# COCA-COLA NORTH AMERICA EQUIPMENT BULLETIN... SERVICE

**NUMBER:** SERV-249

**SUBJECT:** ABS Umbilical Assembly Installation Guide

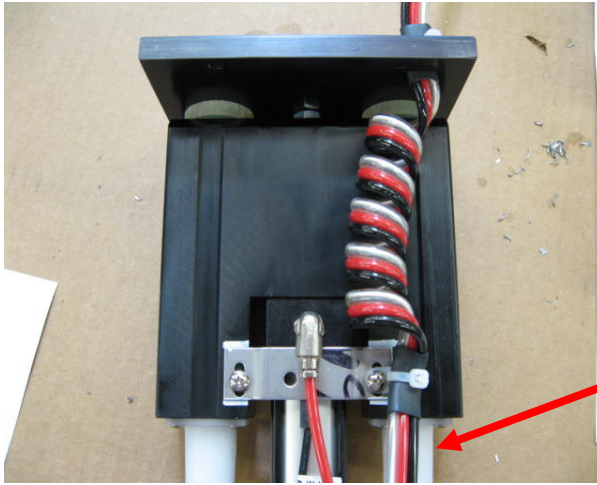
The assembly comes with a metal adapter plate that is only used with the older "PHD" lift cylinders along with two tie-wraps. Note: the older two wire sold-out harness cannot be used on the new lift assembly.

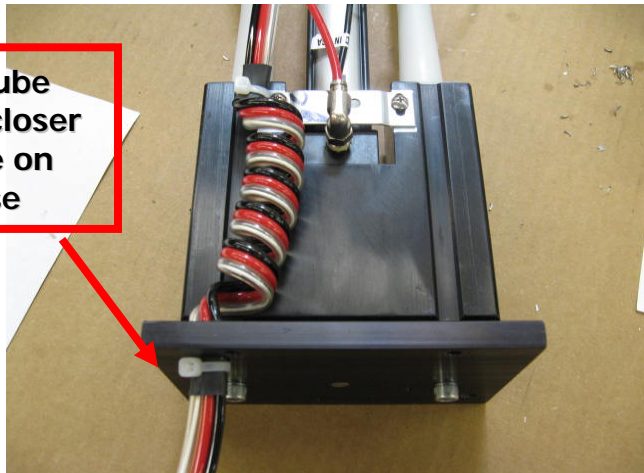
The black tube should be closer to the edge near the full travel sensor as shown here

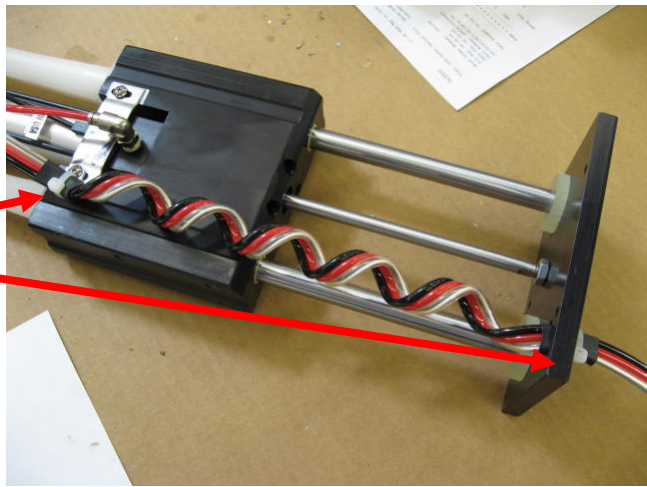
The 2 tie-wraps should be over the black sheathing and should be orientated correctly. The tie-wrap near the bracket is CCP#1066691 (Does not come with the Umbilical)

The clear tube should be closer to the edge on the top base
